Alpine Street
Garage

11-15 ALPINE STREET
SOMERVILLE, MA

REVISION TO ZBA 2016-75
September 30, 2021

List of Changes; Refer to Accompanying Narrative.

Garage Floor Plan

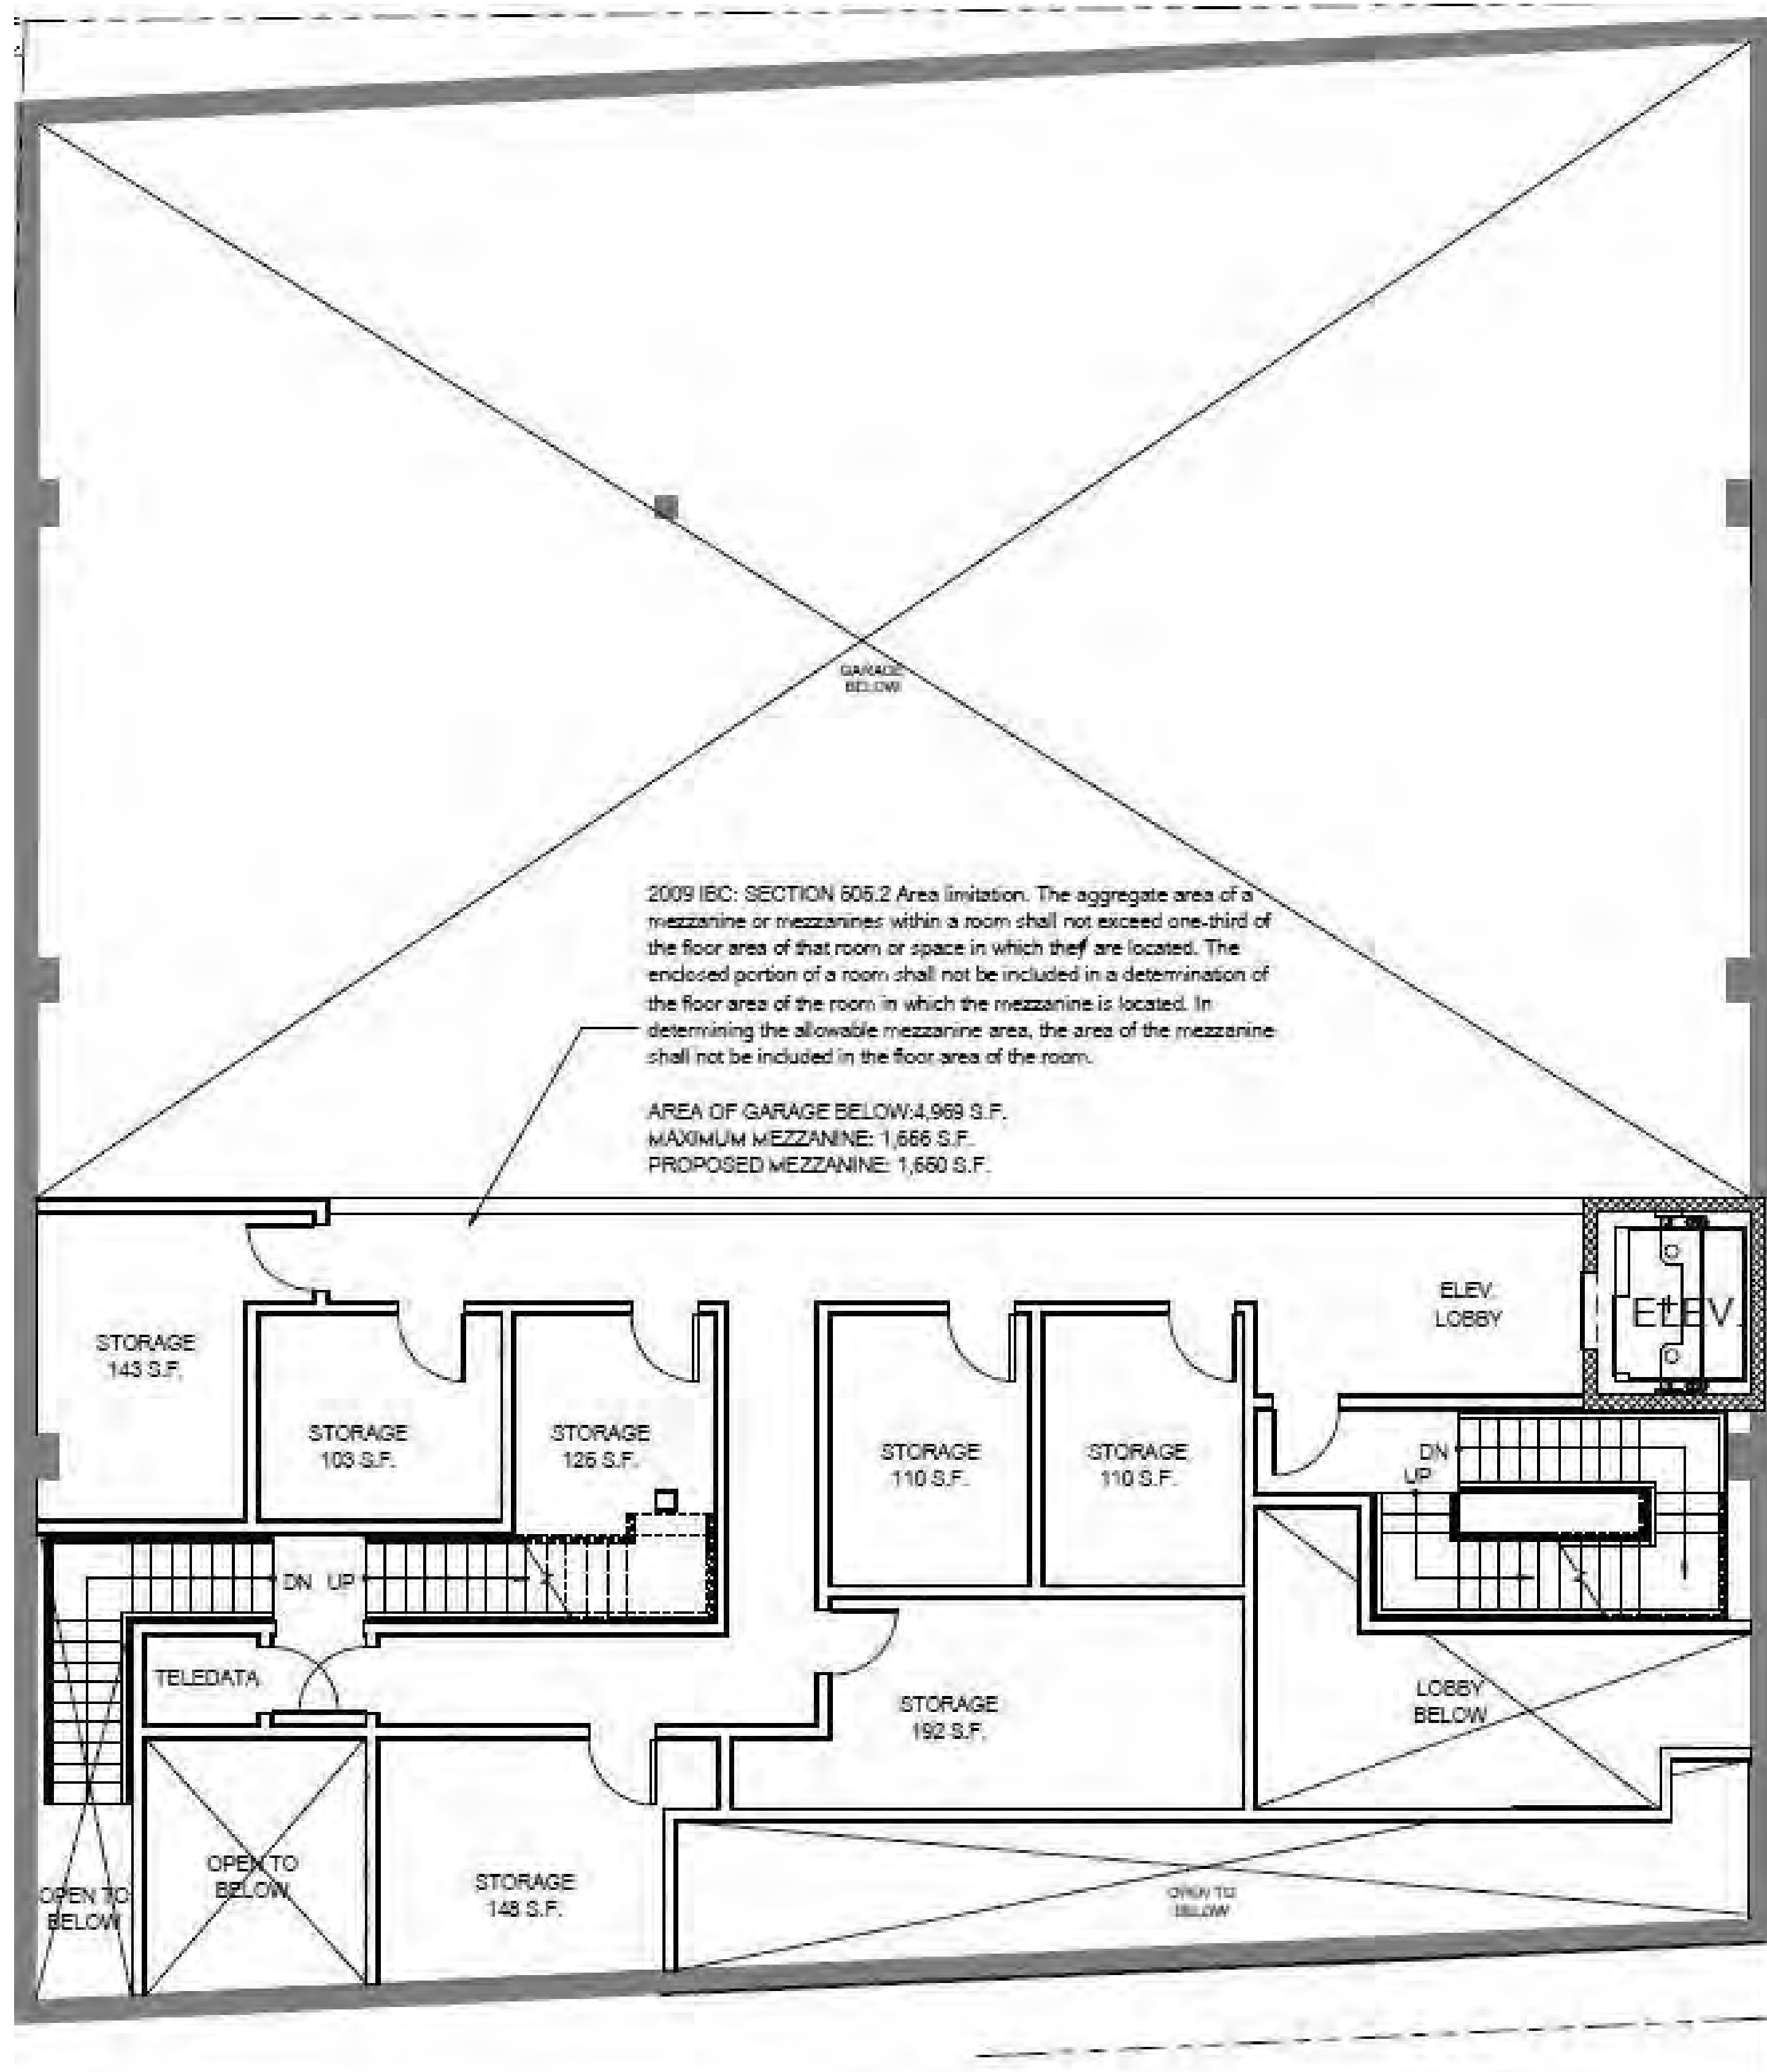
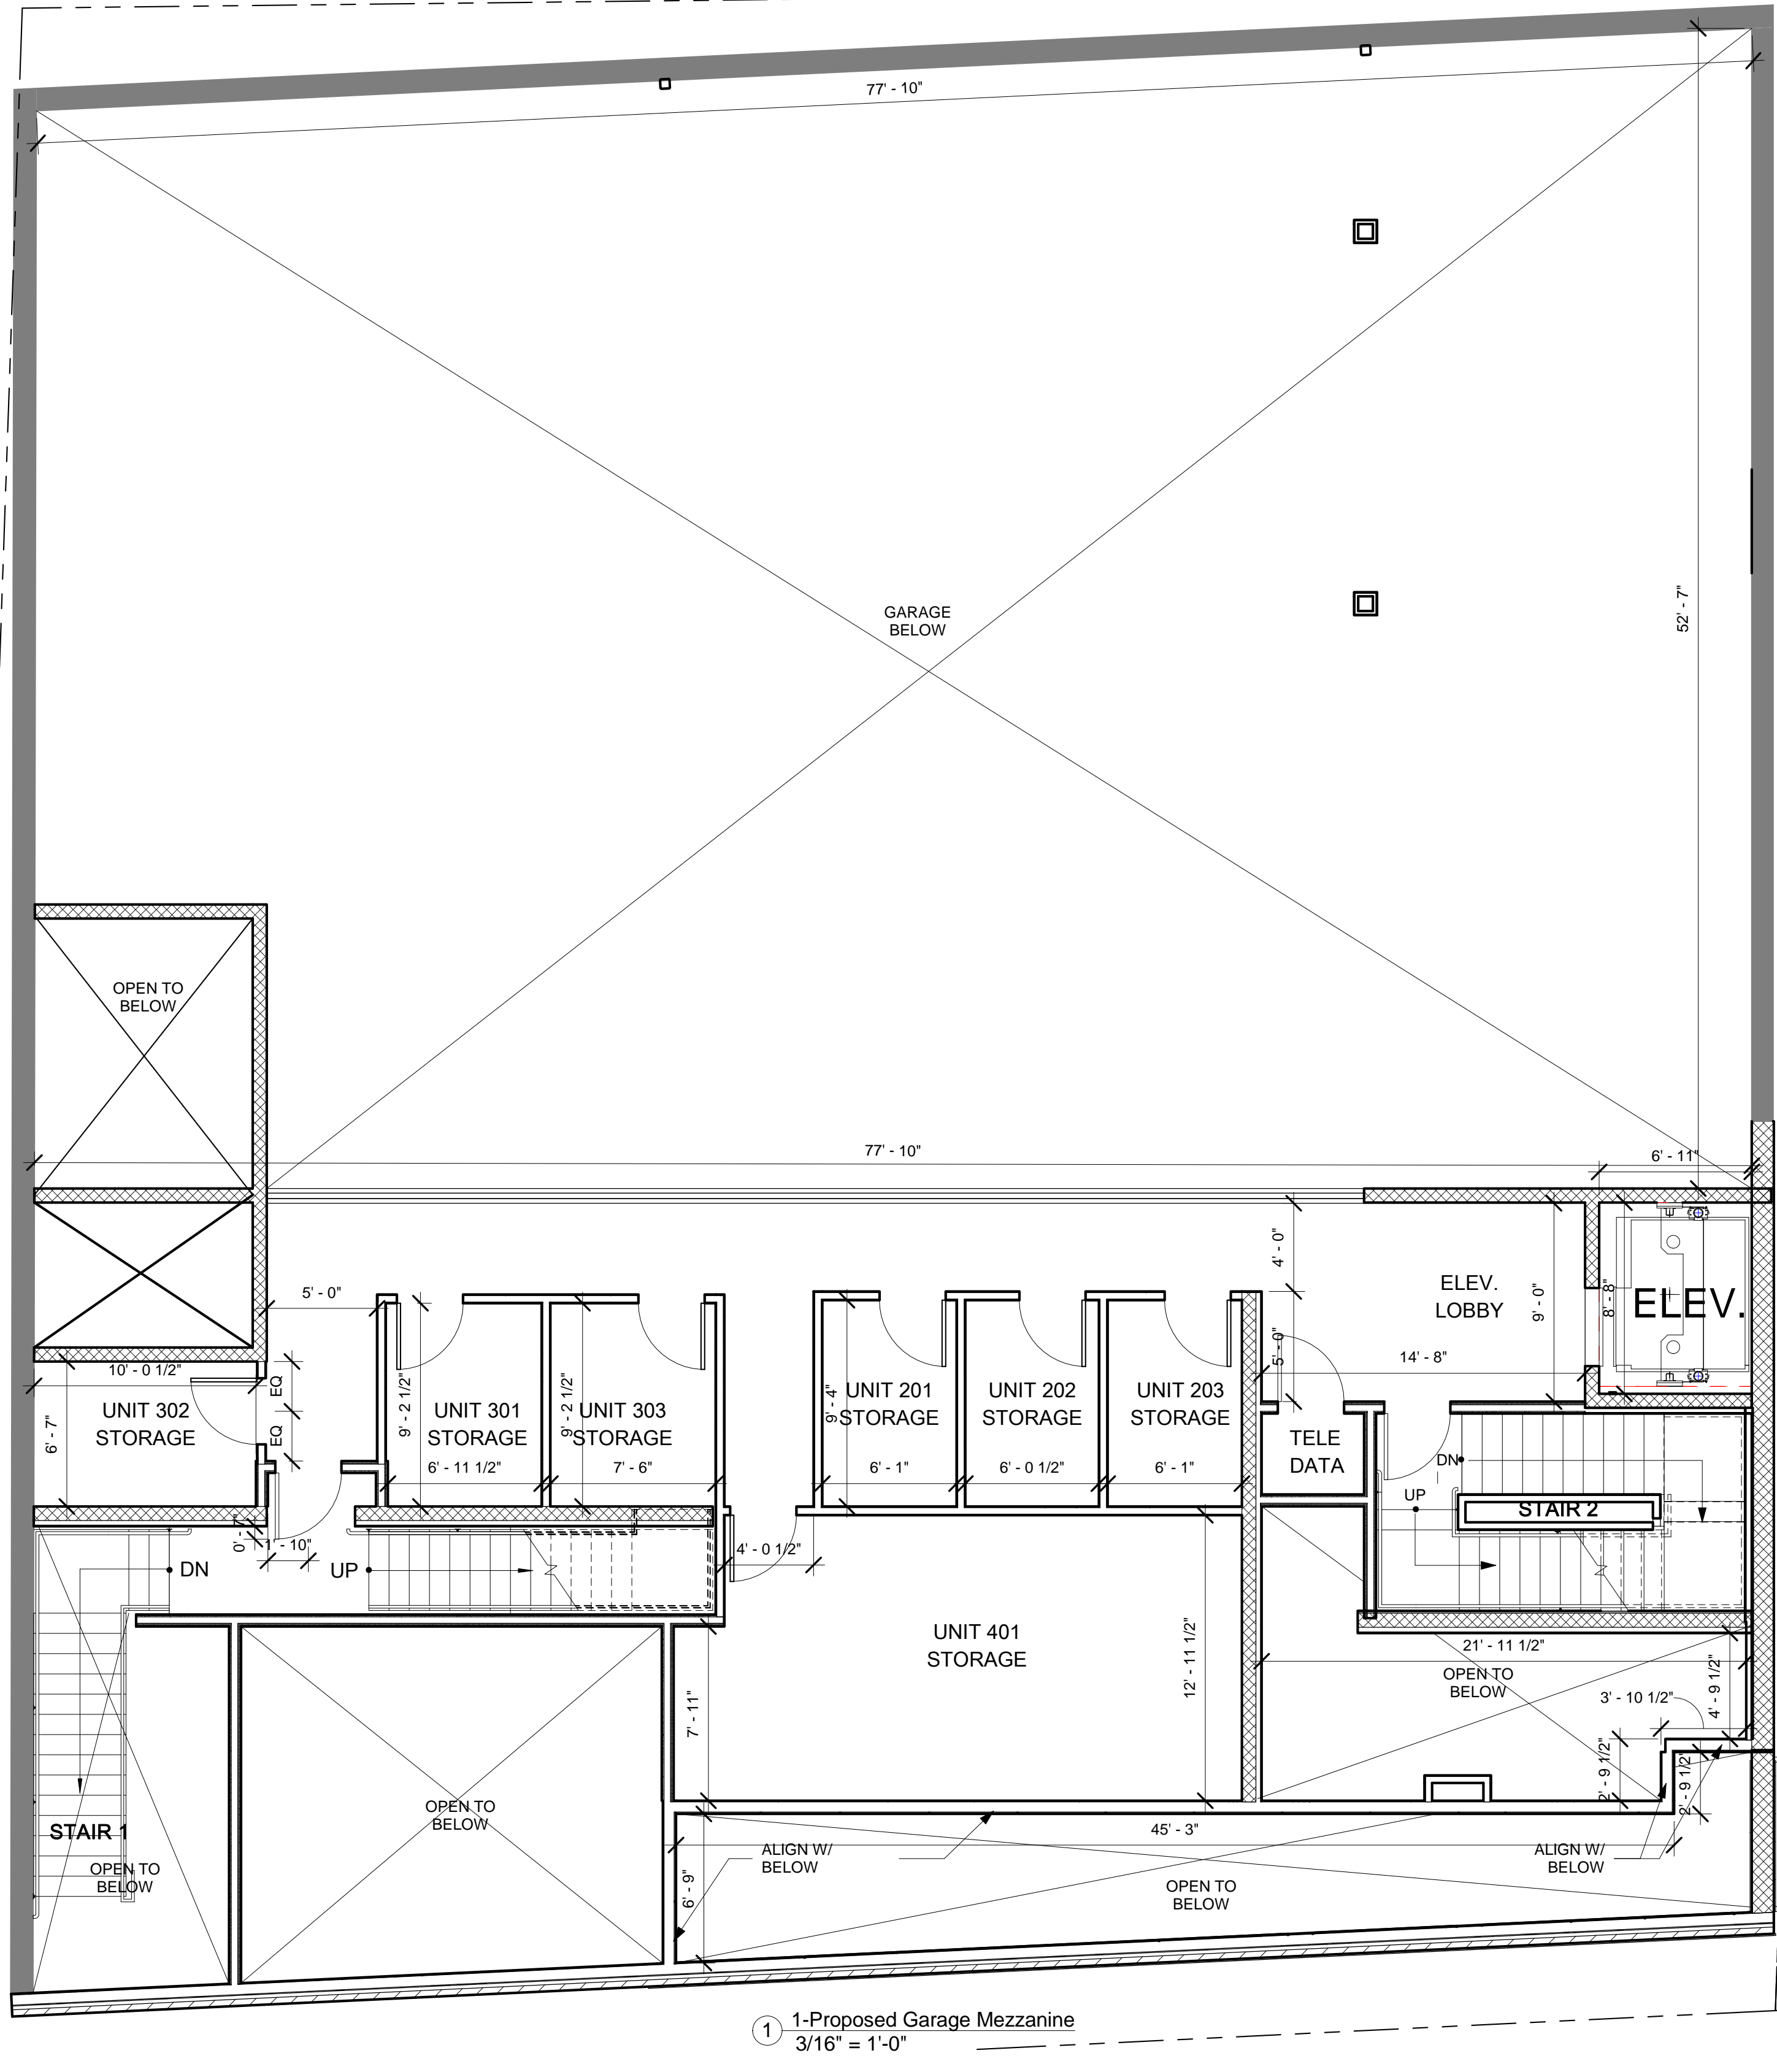
5. CMU Block is used at the
east side garage wall in lieu of
opaque glazing.

12- Cast concrete planters at the front of
the building on the ground floor are being
proposed.

DESIGN INTENT: BOARD FORMED CONCRETE TO CREATE
A WOOD TEXTURE
